BT07-039

## 2008 G37 COUPE; QUARTER GLASS MOLDING IS NOT FLAT

**APPLIED VEHICLE:** 2008 G37 Coupe (CV36)

Figure 1

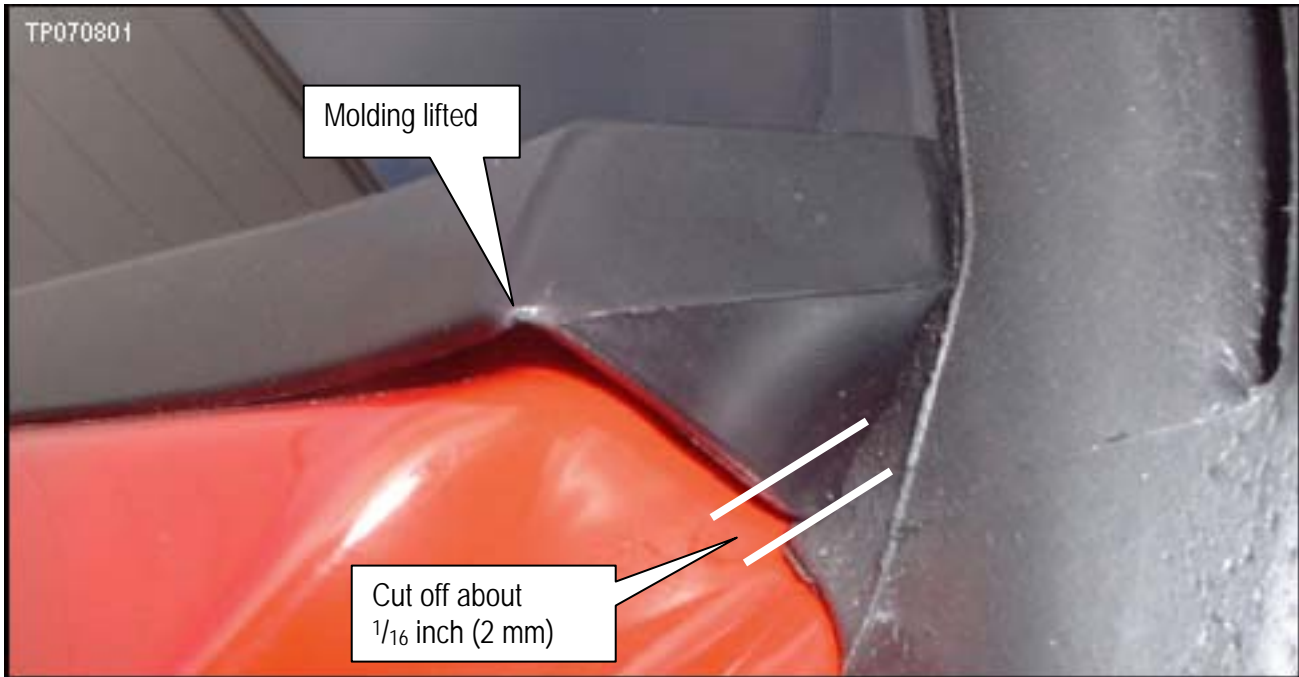
The front end of the quarter glass molding is lifted and will not stay flat to the body (left and/or right side).

Cut about 1/16 inch (2 mm) off of the front edge of the molding as shown in the Service Procedure.
